REMARKS

MARKED-UP DRAWING

FIG. 2

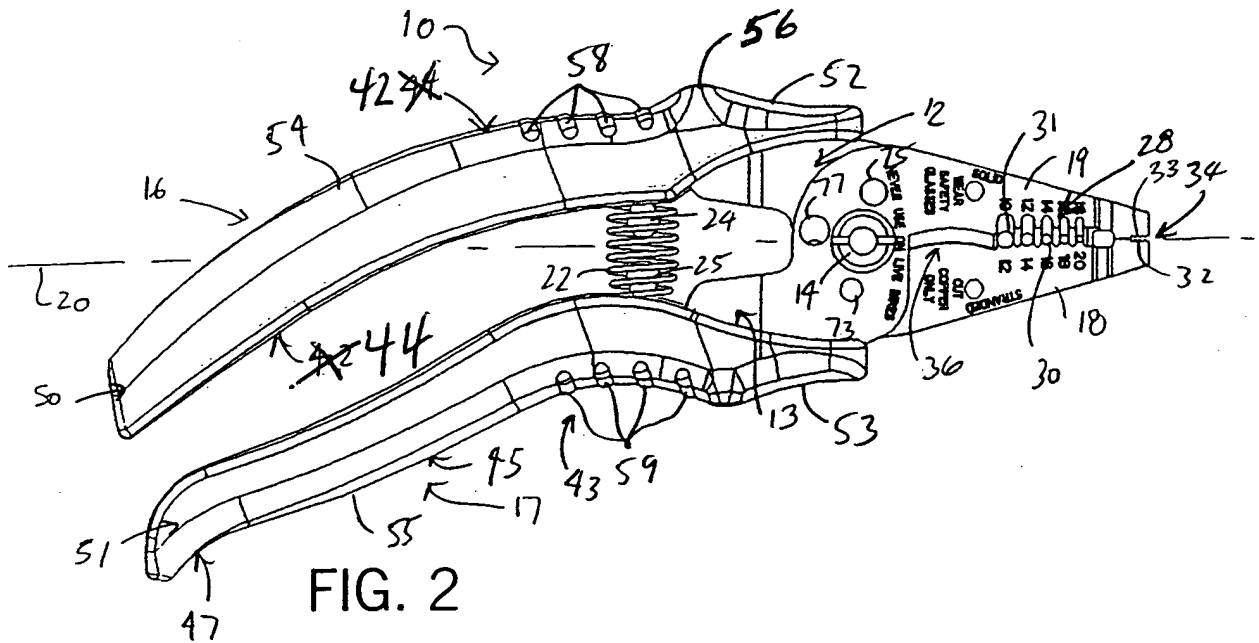
The drawings were objected to for incorrect reference numbering in FIG. 2. Enclosed is a marked up and replacement sheet showing FIG. 2 with reference numbers 42 and 44 interchanged. This is believed to overcome the cited objection. Figure 2 is also being amended to replace incorrect reference number "5" with --56--. Formal drawings will be provided following allowance of the application.
